**CAROLINA DIVISION OF  
AIR QUALITY**

**Application Review – Final PSD Determination**

**Issue Date: May 23, 2022**

North Carolina Renewable Power – Lumberton, LLC (NCRP) currently holds Title V Permit No. 05543T28 with an expiration date of August 31, 2022 for a power plant in Lumberton, Robeson County, North Carolina (the “facility”).

*Belt dryers*

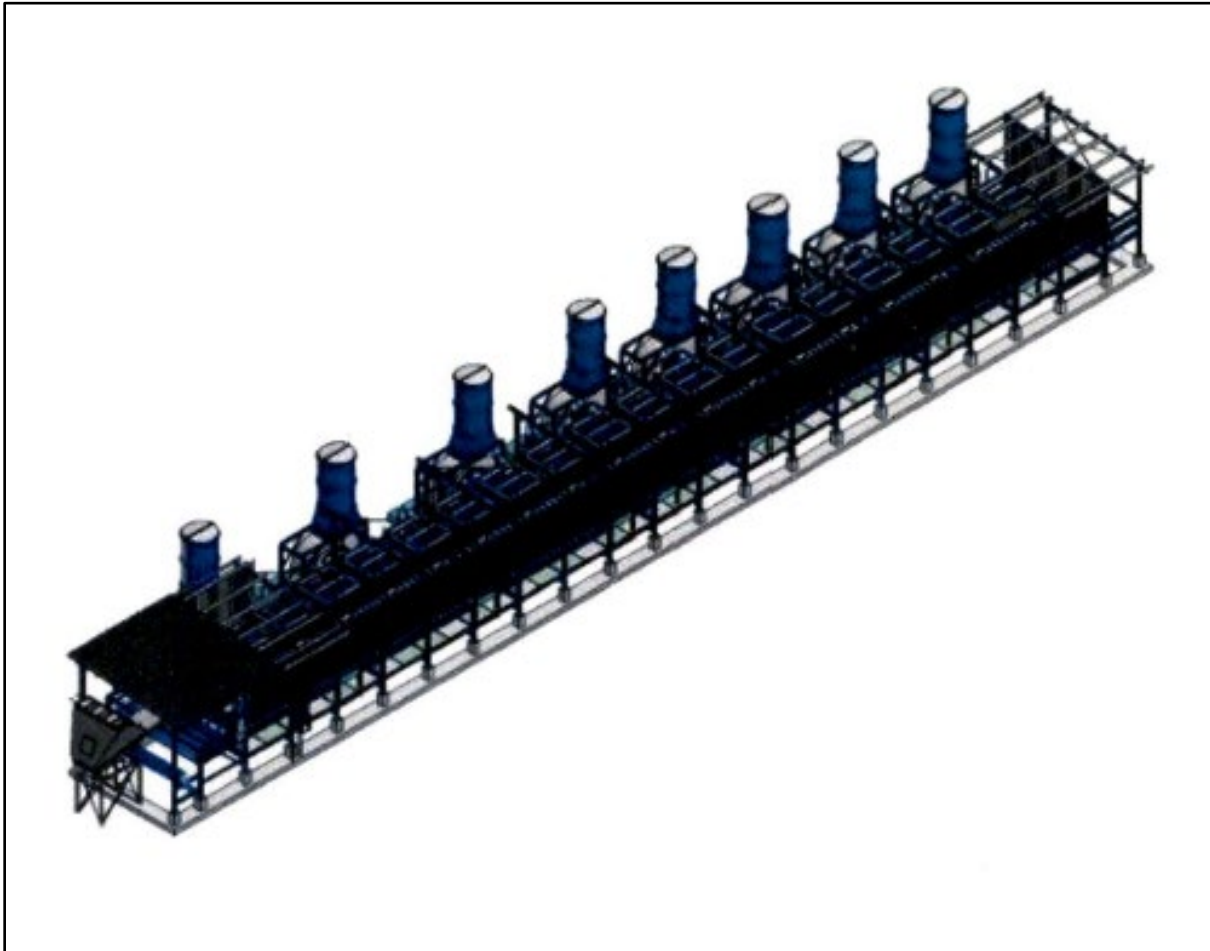
Commenters objected to NCDAQ’s dismissal of a regenerative thermal oxidizer (RTO) as control on the belt dryers (ID Nos. ES-17, ES-18, and ES-19) and of a regenerative catalytic oxidizer (RCO) as control on the boilers (ID Nos. ES-1A and ES-1B) for being technically infeasible. These emission sources and their associated controls are discussed separately below.

This discussion is intended to supplement the information in Section 4.4.11.1 of the draft permit review.

DAQ performed an investigation to identify current regulatory BACT/LAER determinations for belt dryers. The investigation involved a review of US EPA’s RBLC, which included information on BACT and LAER decisions throughout the country. Specifically, NCDAQ performed a search of the RBLC database for the years 2008 – 2022 using the following criteria:

Even if the RTO had been deemed technically feasible, the technology would be dismissed for its high cost-effectiveness of VOC removal. RTOs can be effective at inlet loadings as low as 100 ppmv or less, but extremely low concentrations (less than 100 ppmv) are associated with much higher cost, according to US EPA's "Air Pollution Control Technology Fact Sheet for Regenerative Thermal Incinerators."<sup>4</sup> As an example, the NCDAQ used data measured during testing and methodology in EPA's Air Pollution Cost Control Manual<sup>5</sup> to demonstrate the high cost-effectiveness associated with an RTO for the belt dryers. The cost impacts are presented in the table below. These values represent a rough estimate based on the limited data available (e.g., test data and default data from EPA) but illustrate the high cost with controlling VOC from only one stack on the belt dryer with an RTO.
